Re: **Comments Concerning Widespread Improper Reliance on Inadequate Analysis Concerning Hydrologic Connectivity of Groundwater Wells**
(Commercial Cannabis Permitting Program Under the CMMLUO and CCLUO)

Re: Comments re Reliance on Insufficient Analysis Concerning
Hydrologic Connectivity

Re: Review of Hydrogeologic Connection Investigation Memorandum Prepared for Platinum King Commercial Cannabis Project (Humboldt County, PLN-2018-15196)

**FIGURE 1: GEOLOGICAL MAP OF REGION SURROUNDING
PLATINUM KING HOLDINGS, PETROLIA, CA**

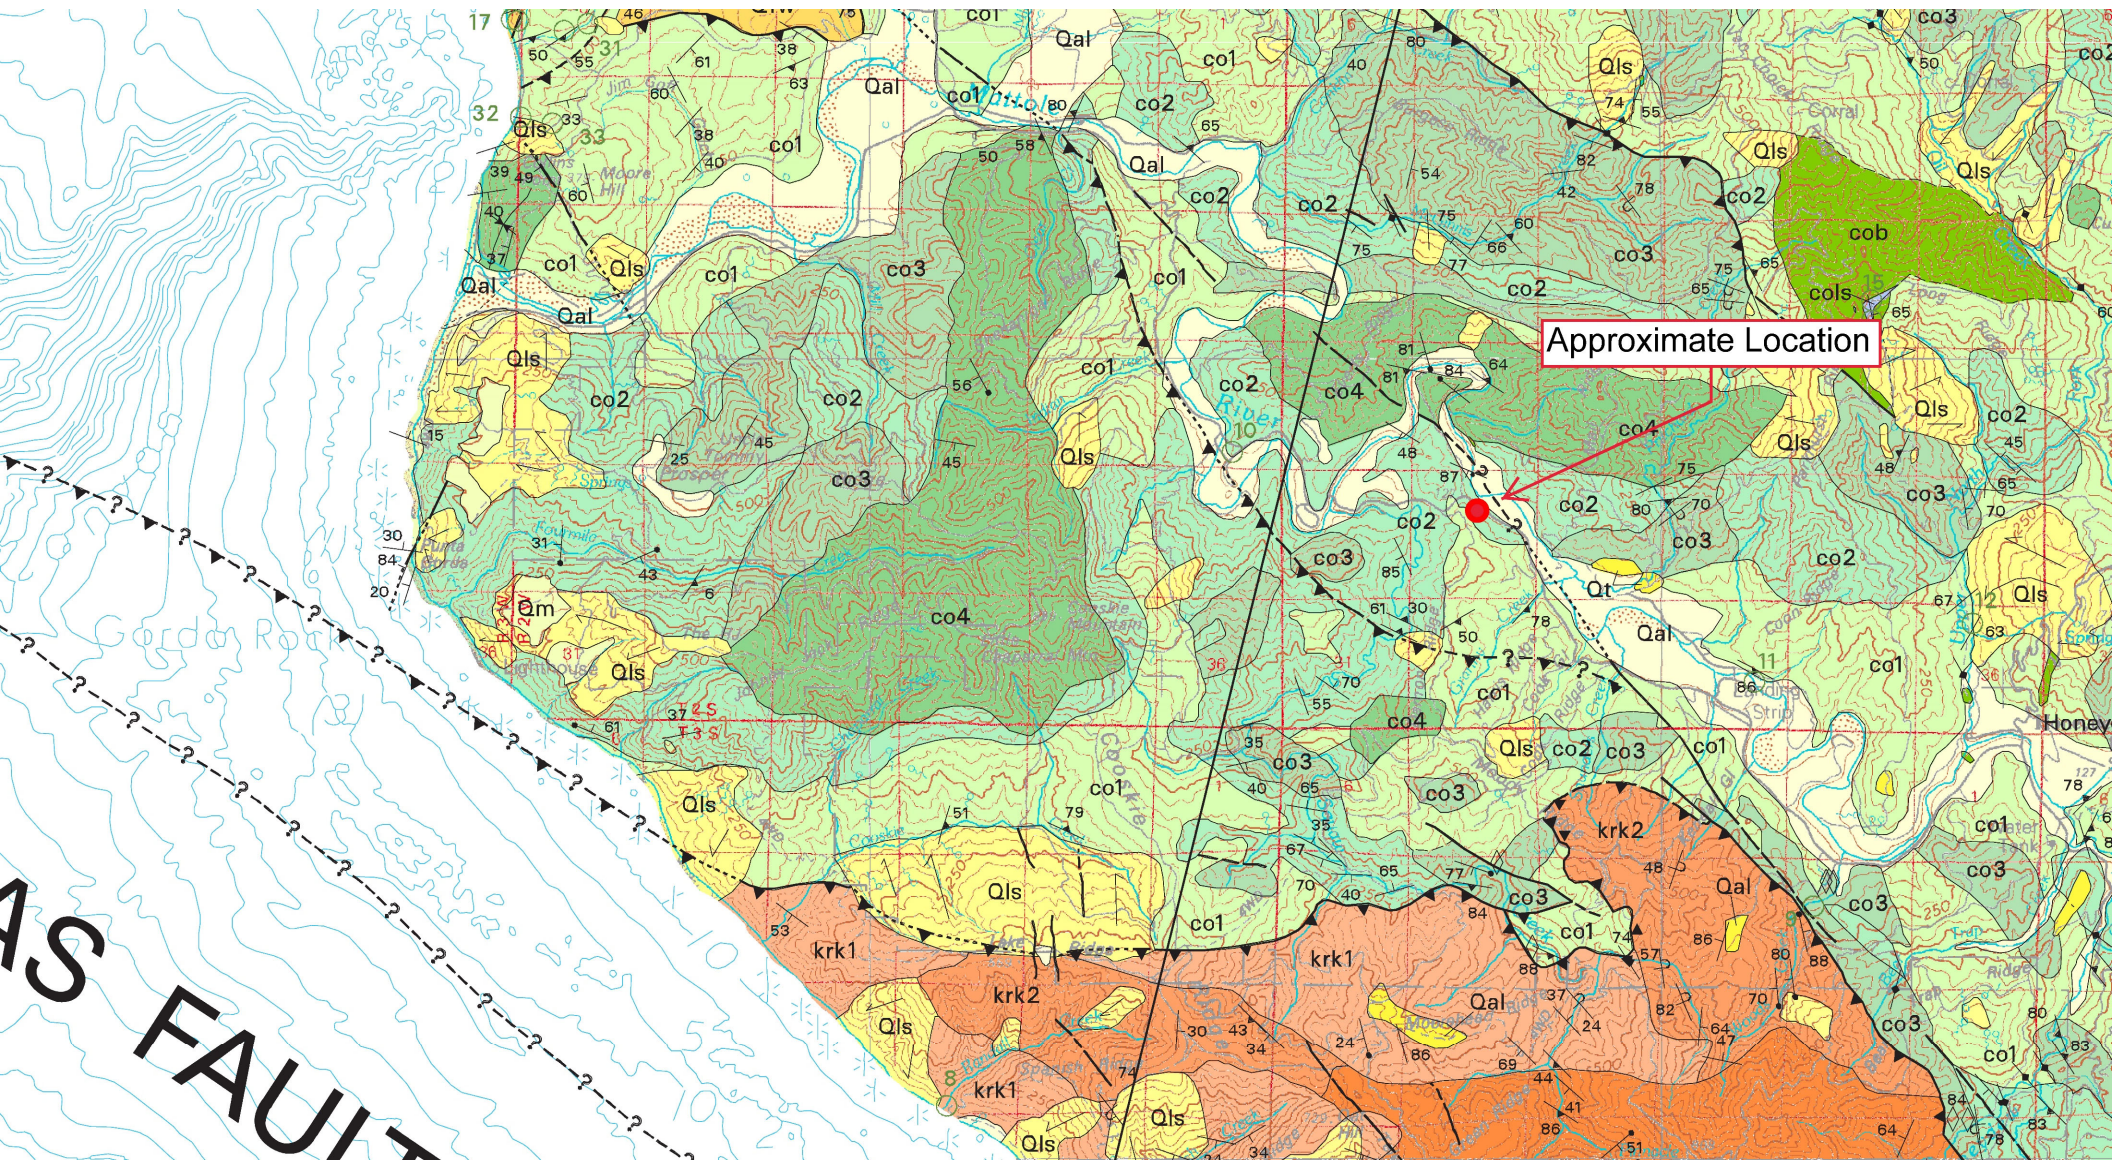
The wells are located near the Mendocino Triple Junction, probably the most seismically active portion of Humboldt County over the past several million years and counting. The local aquifers are heavily deformed, tightly folded, and physically torn apart. Groundwater conditions in the vicinity of the wells have been fundamentally affected. The geologic deformation – and how inconsistent with the memo’s assumption of an extensive confined aquifer -- is not recognized in the Reinhart memo.

- a. Confinement of groundwater conditions require continuity of the affected aquifer, which the local geology does not provide:** The memo claims that confinement is the mechanism by which surface water bodies can be isolated from groundwater pumped at the two wells, which the memo implies may be interconnected. Any confining geologic unit must logically extend at least the distance (seemingly several hundred yards) between the two wells, and substantially beyond them. The geologic conditions at the site do not provide for such continuity. But there is nothing gentle, flat, or continuous about the local geologic structure. Figure 1 (Attachment C) shows geologic units which dip steeply and in almost every direction, chaotically folded. And the map shows that Coastal-Belt Franciscan deposits underlying the Reynolds Road area, even if not fragmented by the chaotic folding, are mélanges -- so fine-grained, squeezed, having peanut-

The likelihood of continuous aquifers or aquitards in the Reynolds Road area is vanishingly small.

⁶ The cross section is located along the thin line trending northeastward through Figure 1.
